Revision	Approved by	Number of Pages
000		122
Approval Date	06/10/2020	
<div style="text-align: center;">  <p>General Nuclear System</p> <p>General Nuclear System Ltd.</p> </div>		
<p style="text-align: center;">UK HPR1000 GDA Project</p>		
Document Reference:	HPR/GDA/PCSRV1AR/0000	
<p>Title:</p> <p style="text-align: center;">Pre-Construction Safety Report V1 Amendment Report For EA Public Consultation</p>		
<p>This document has been prepared on behalf of General Nuclear System Limited with the support of China General Nuclear Power Corporation (CGN) and Électricité de France S.A. (EDF).</p> <p>Although due care has been taken in compiling the content of this document, neither General Nuclear System Limited, CGN, EDF nor any of their respective affiliates accept any liability in respect to any errors, omissions or inaccuracies contained or referred to in it.</p>		
<p>Text within this document that is enclosed within brackets '{...}' contains Sensitive Information and has been removed.</p>

UK HPR1000 GDA	Pre-Construction Safety Report V1 Amendment Report for EA Public Consultation	UK Protective Marking: Not Protectively Marked	
		Rev: 000	Page: 1 / 17

F-10.4-1 Simplified Diagram of the RCV [CVCS]

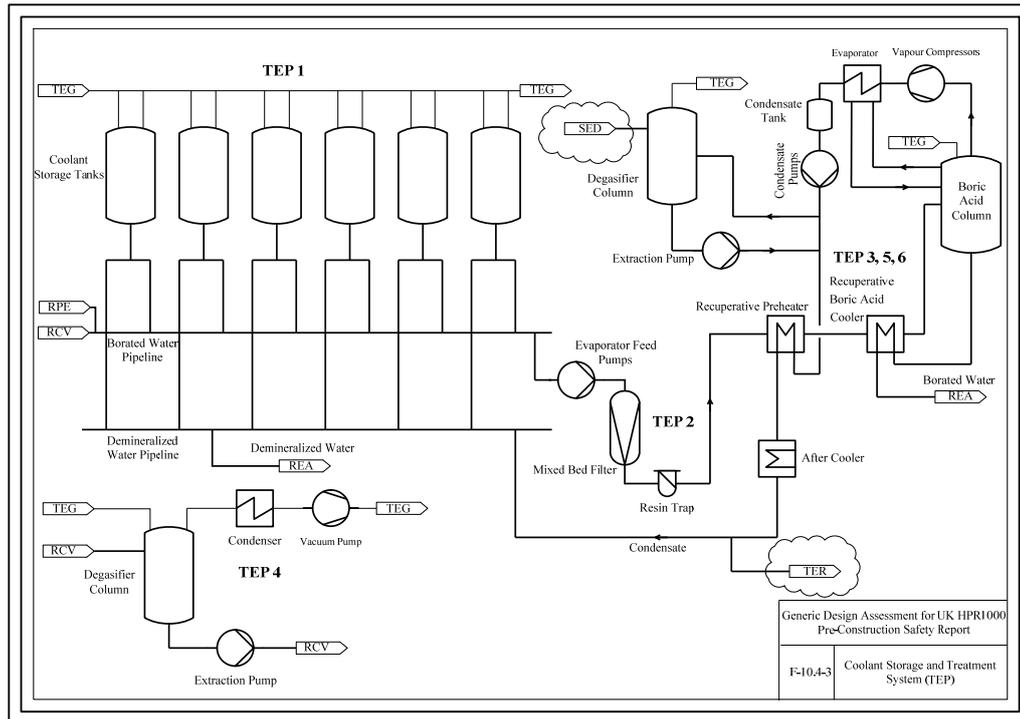
In the diagram “*F-10.4-1 Simplified Diagram of the RCV [CVCS]*”, the zinc injection unit is added as follows:

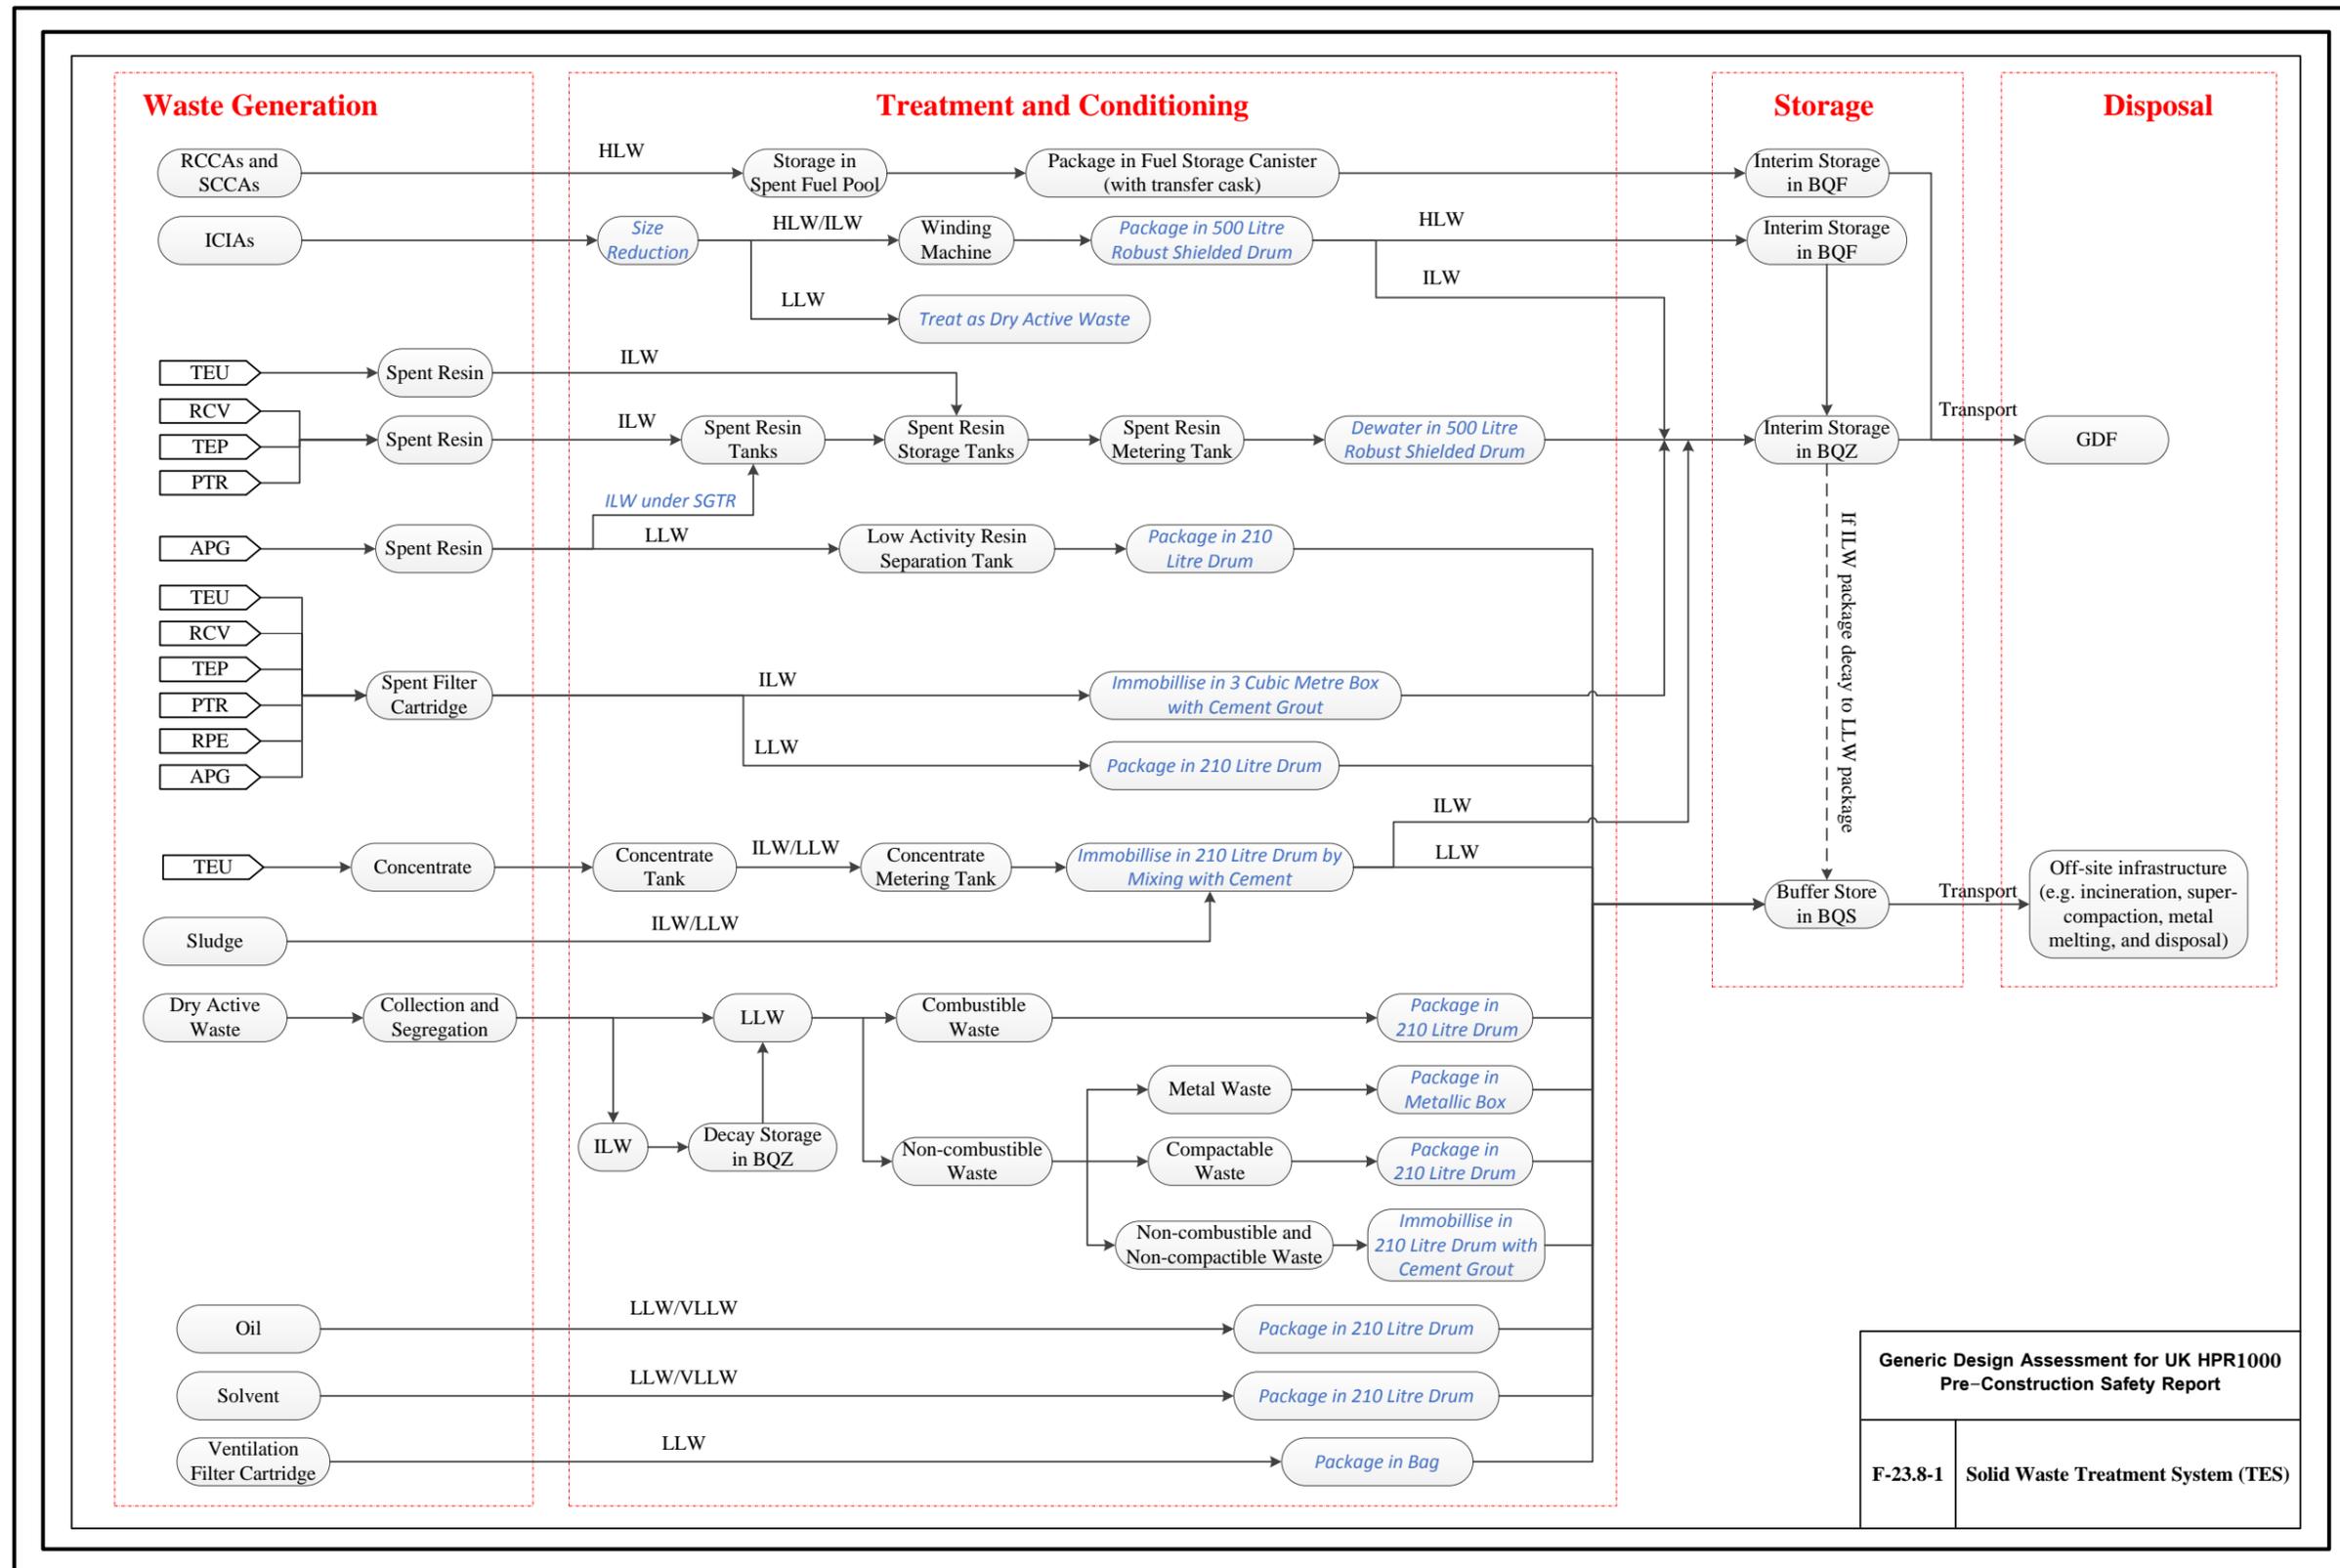
In the diagram “*F-23.8-1 Solid Waste Treatment System (TES)*”, the Category of the “*RCCAs and SCCAs*”, the management routes of the “*ICIAs*” and “*Ventilation Filter Cartridge*” and the terminology are modified.

Appendix 29B

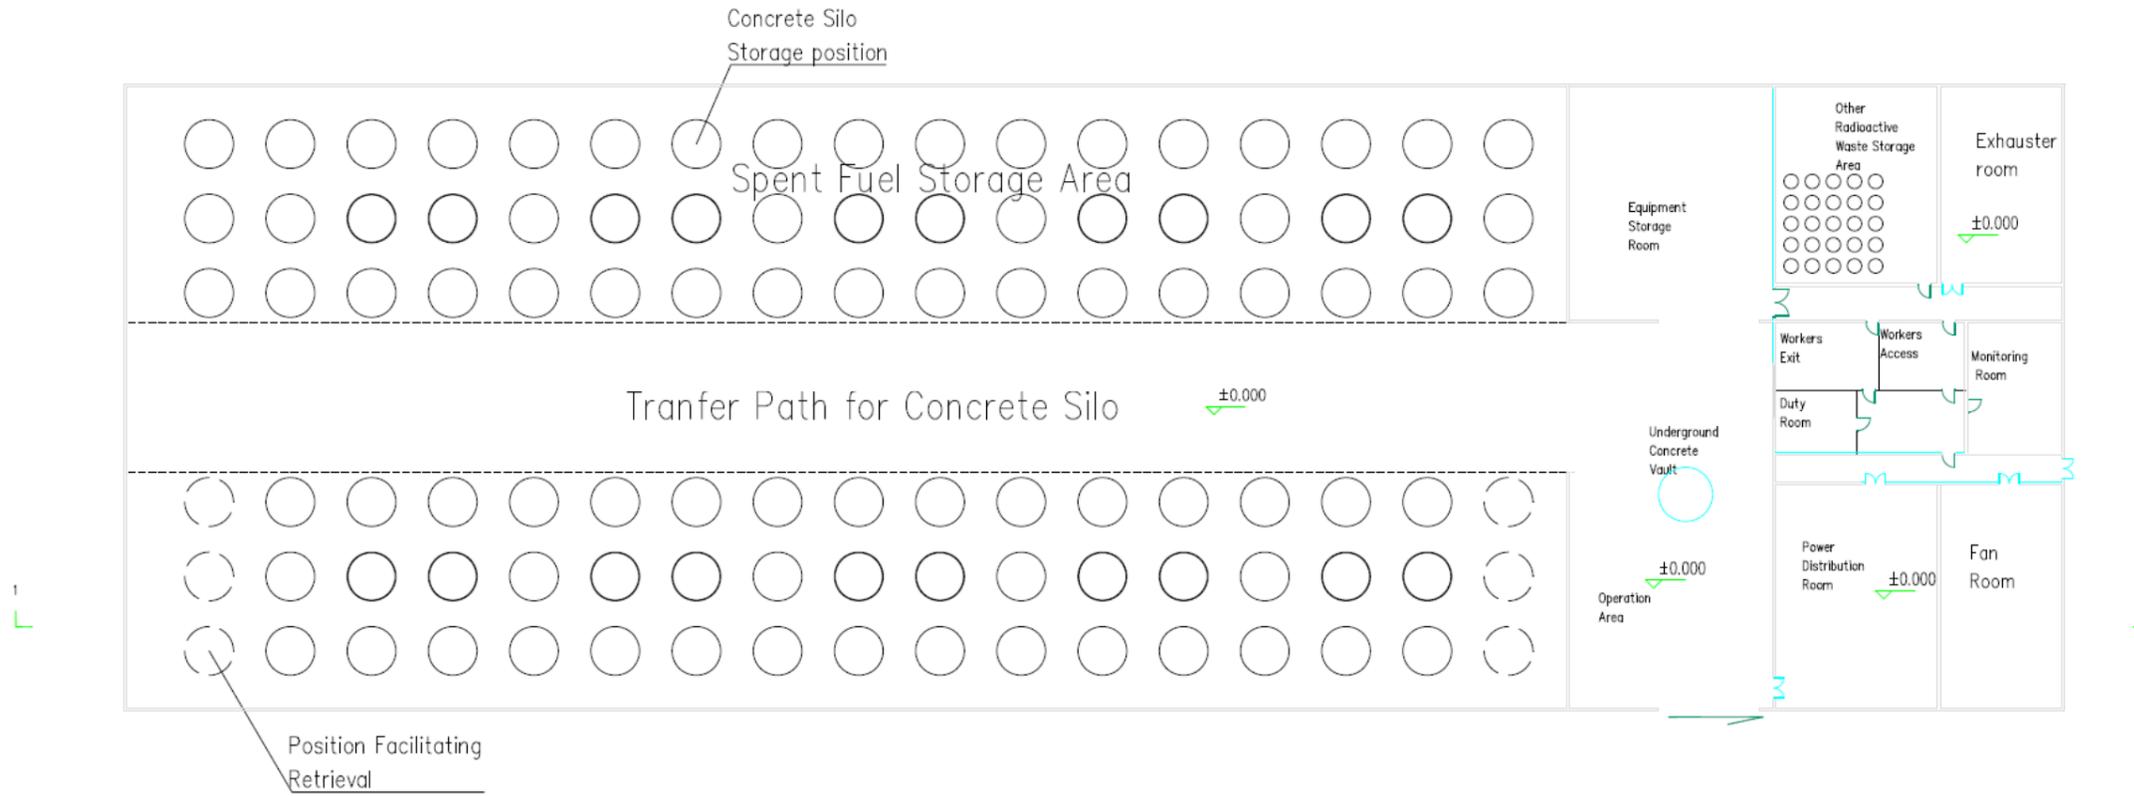
The figure in the Appendix 29B of PCSR Chapter 29 is modified to:
